**Town of Gawler
Council Assessment Panel**

Item		Page No
5.7	Development Application: 490/303/2017 (490/D018/17)	301
	Applicant: C G WYATT	
	Address: 23 Potts Road EVANSTON PARK 5116	
	Nature of Development: Land Division by Torrens Title (1 into 2) and removal of one Regulated Tree (Eucalyptus cladocalyx - Sugar Gum) & one Significant Tree (Eucalyptus camaldensis - River Red Gum)	
	Attachment 1 – Application Plans and Documentation	302
	Attachment 2 – Applicant's Hydrological Report	310
	Attachment 3 – Applicant's Arborist Report	321
	Attachment 4 – Council Commissioned Arborist Report	351
	Attachment 5 – External Referrals	365
	Attachment 6 – Internal Referrals	366
	Attachment 7 – Photographs of Watercourse 16 August 2017	367

PROJECT
**PROPOSED LAND DIVISION
AT: 23 POTTS ROAD,
EVANSTON PARK**

FLOOD ADVICE - 23 POTTS ROAD EVANSTON PARK

DRAWING TITLE
CIVIL PLAN

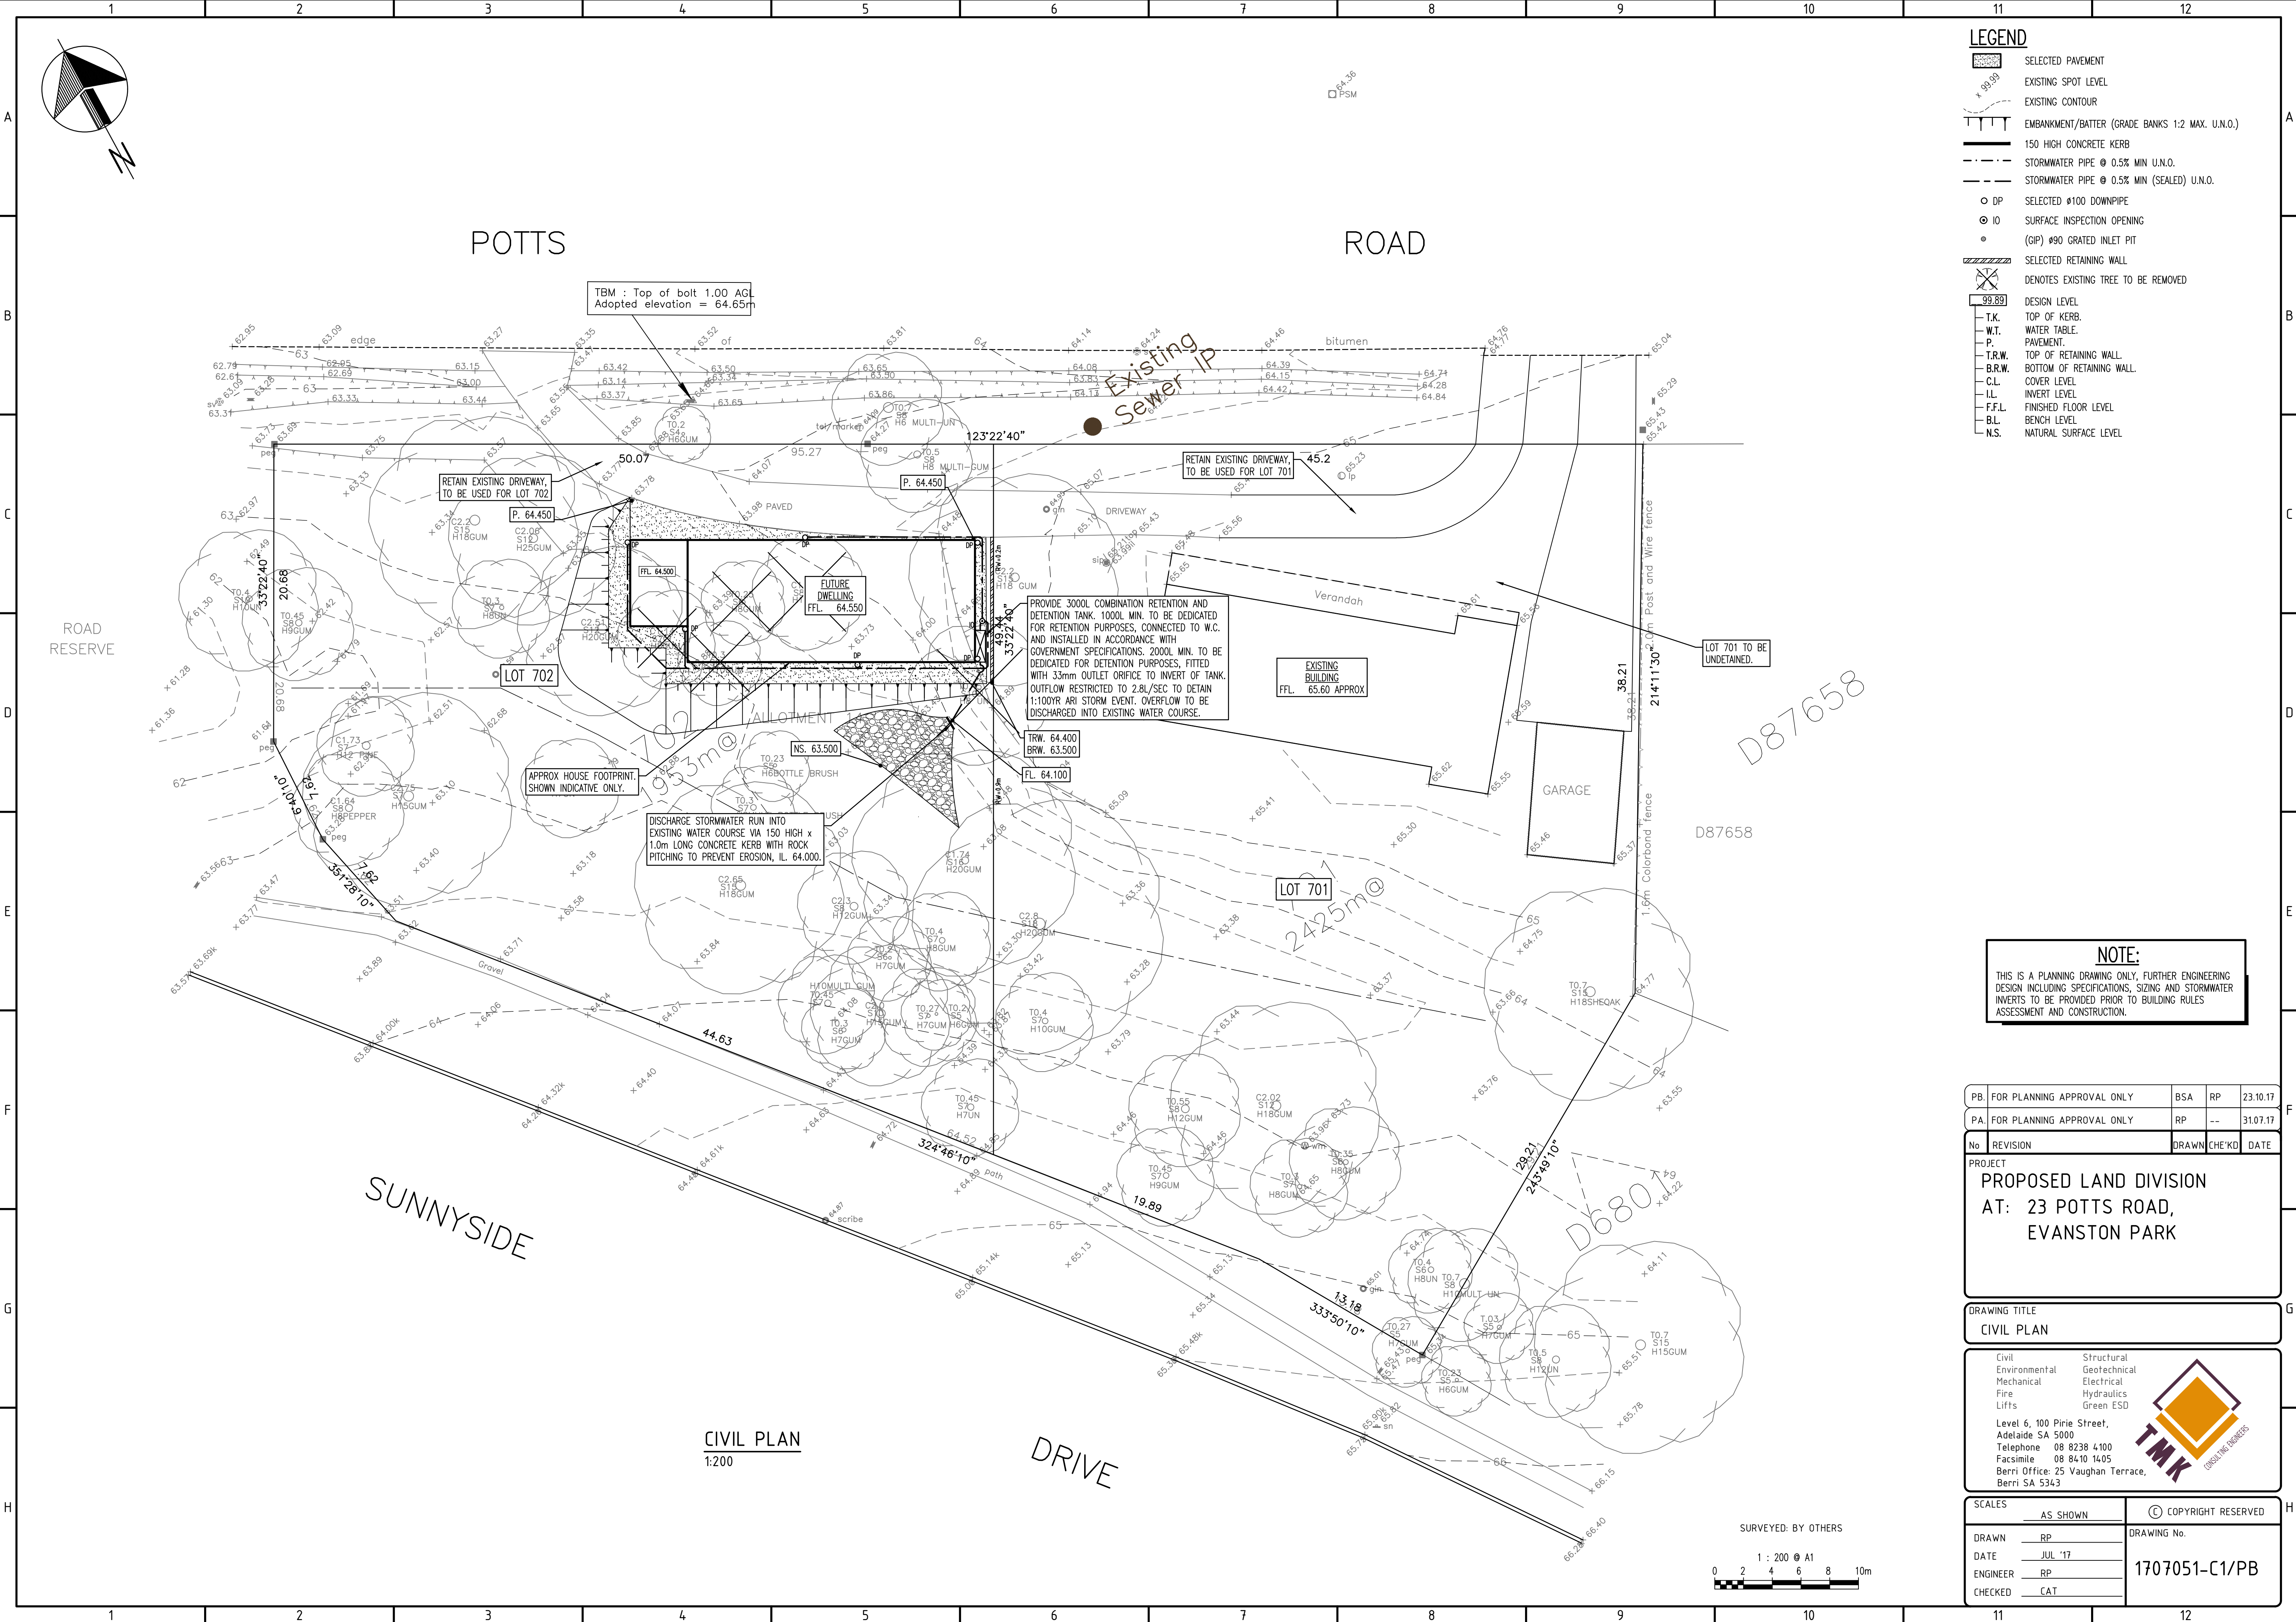
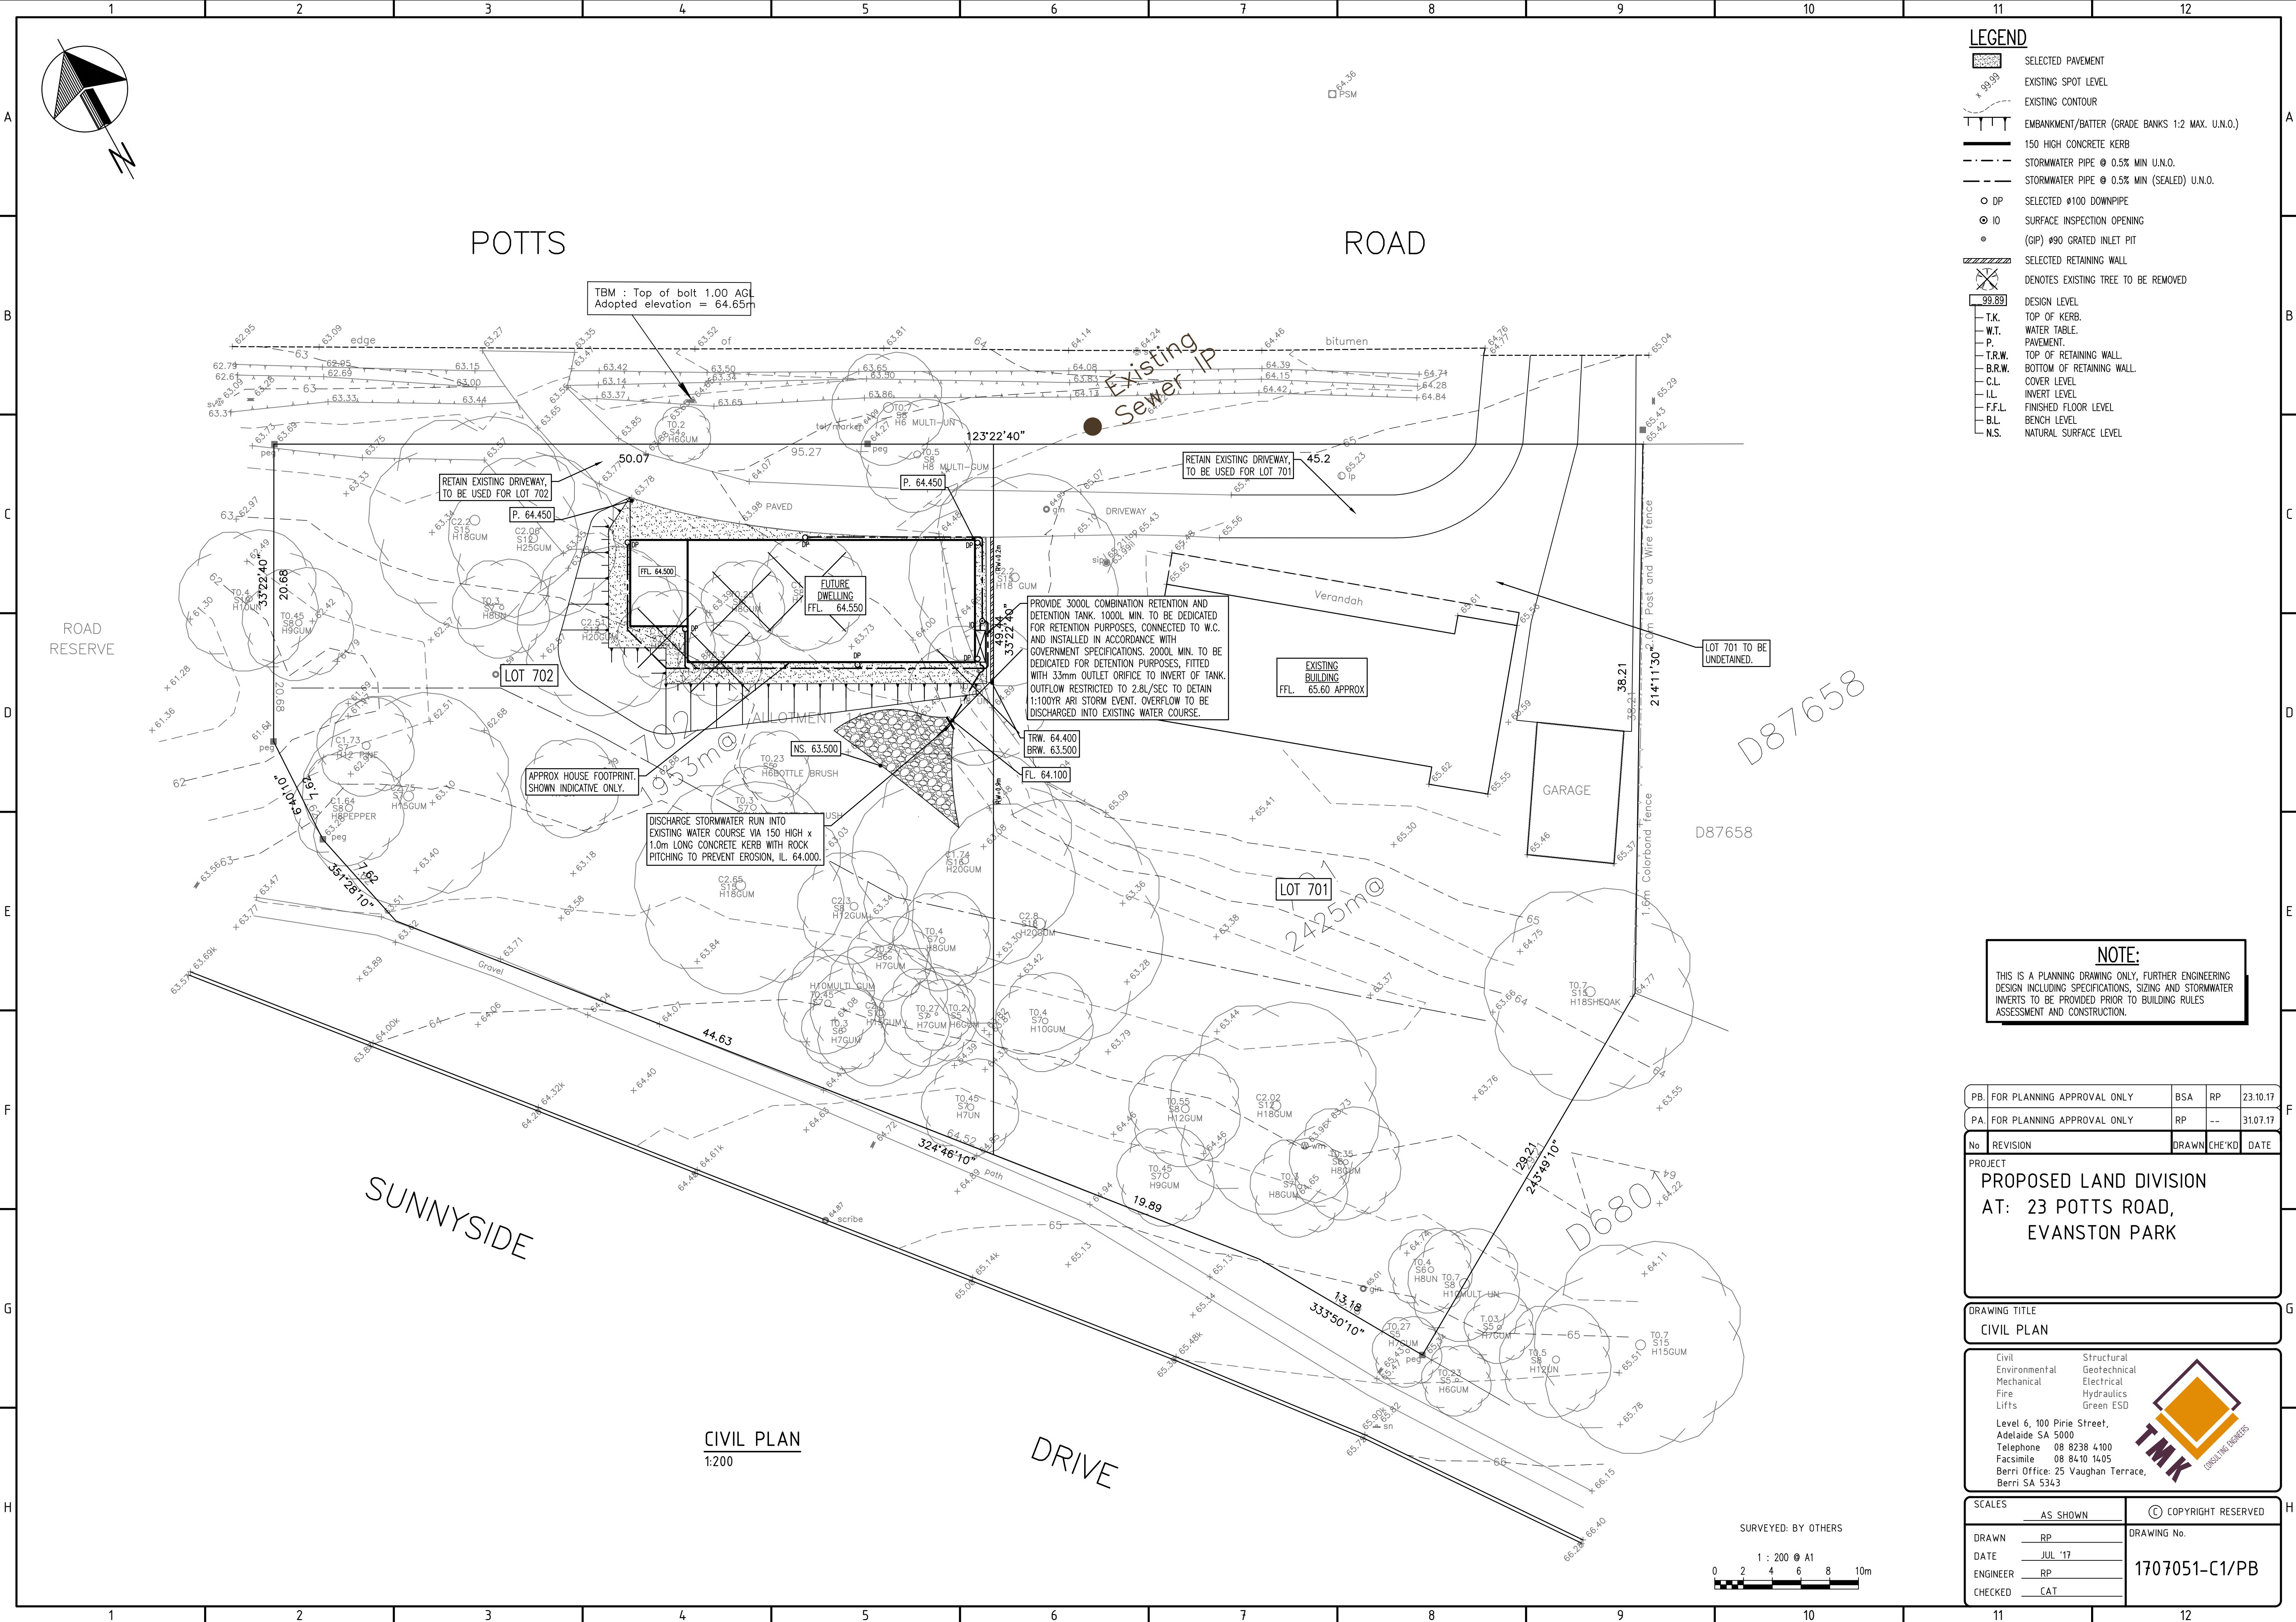
1. Setting a floor level based on HEC-RAS modelling of the watercourse. Current floor level is adequate.
2. Potential for increasing the risk of flooding adjacent properties as a result of reducing the watercourse flow area. Impact on upstream flood level is limited to the upstream Lot.
3. Increased risk of erosion of fill in the watercourse. The applicant should provide erosion control on the batter to reduce the risk of erosion of the batter during high flow events. It will be important to protect the toe of the batter to reduce the risk of undermining.

Figure 2: 100 year ARI Floodplain Extents

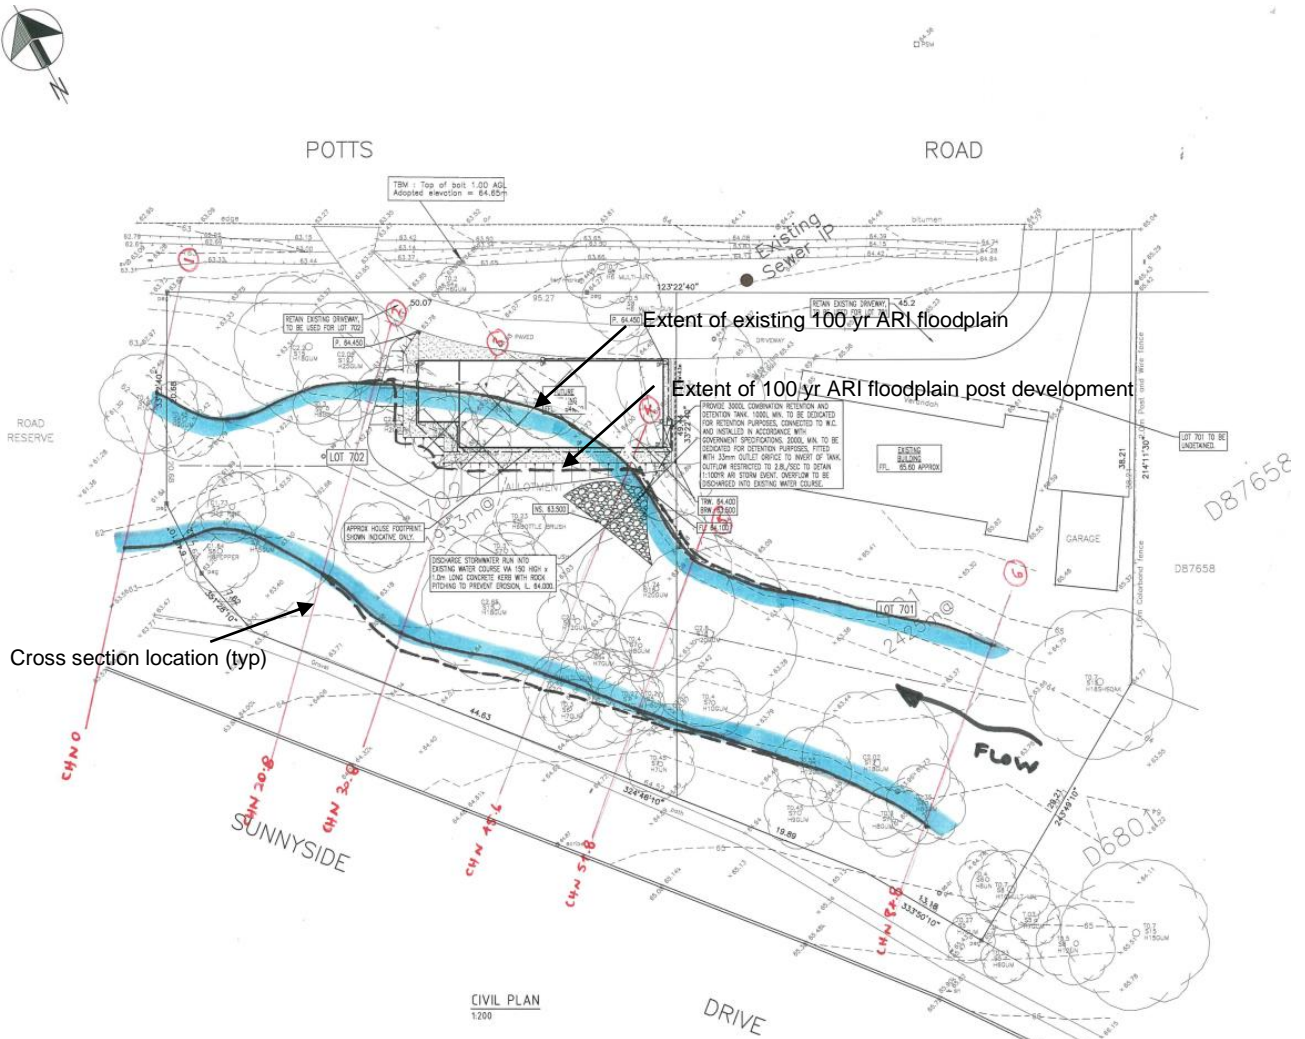
The analysis showed that the filling for the proposed development will produce a localised increase in flood levels within Lot 702 of between 100 and 200 mm. At the upstream boundary of Lot 702, the increase reduces to 50 mm, with flood levels matching existing 15 m inside of Lot 701.

Figure 2 shows the flood extents for the existing and proposed conditions. Due to the relatively steep sided nature of the watercourse, the increase in flood extent within Lot 701 is relatively minor.

- The proposed residence on Lot 702 should have a minimum finished floor level 64.35 mAHD (providing 300 mm freeboard to the 100 year ARI flood level).
- While the filling for the proposed development produces a localised increase in flood level, its effect on Lot 701 is minor, with the existing residence on this property being well above the 100 year flood level. The proposed development will not affect flooding elsewhere in a 100 year ARI event.

- The filling encroaches not closer to the watercourse than is shown on the TMK Drawings;
- The fill batter be stabilised using densely planted ground covers, or failing this is protected from scour by the placement of rockwork of nominal 300 mm minimum diameter;
- Footings for the proposed residence are pierced through the fill and founded on natural material.
